## Safety Recall Campaign

### Argosy Brake Pedal Assembly on *Freightliner* Vehicles

**SUBJECT: Recall T271/99/A Argosy Brake Pedal Assembly**

## Argosy Brake Pedal Assembly

Fig. 1. Brake Pedal

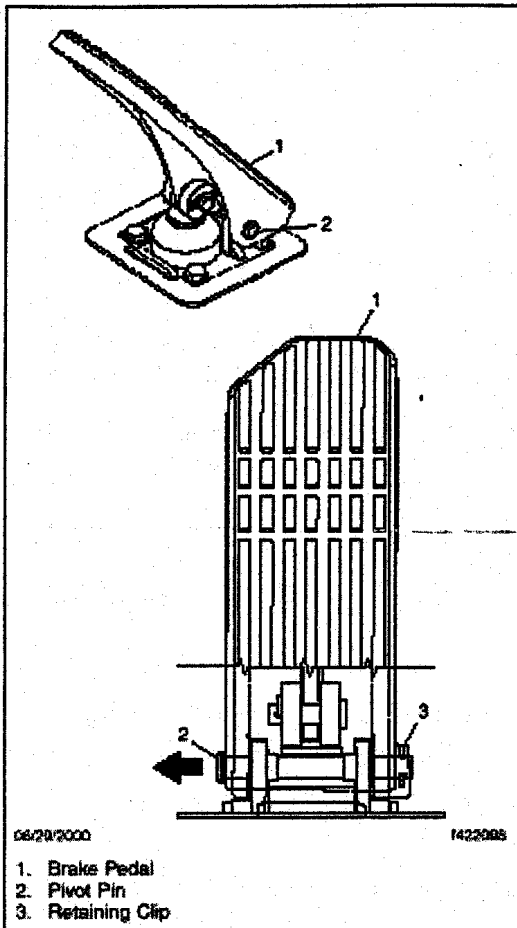
The modification consists of removing and replacing the brake pedal pivot and roller pin with a longer pin that will prevent mis-installation of the retaining clips.

2. Park the vehicle on a level surface, shut down the engine, and apply the park brake.
3. Remove the retaining clip from the pivot pin. Remove the pivot pin from the brake pedal assembly, and remove the brake pedal. See **Fig. 1**. Discard the old retaining clip and pivot pin.

5. Apply grease to the new roller pin. Install the old rollers, new roller pin, and new retaining clip. See **Fig. 3** and **Fig. 4**.
6. Apply grease to the new pivot pin. Install the brake pedal, new pivot pin and new retaining clip. See **Fig. 1**.

Fig. 2. Remove the Retaining Clip

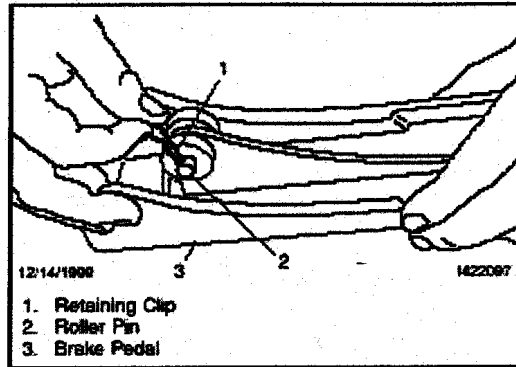
4. Remove the retaining clip from the roller pin. See **Fig. 2**. Remove the roller pin and rollers from the pedal assembly. See **Fig. 3** and **Fig. 4**. Discard the old retaining clip and roller pin, but save the rollers so they can be reused.
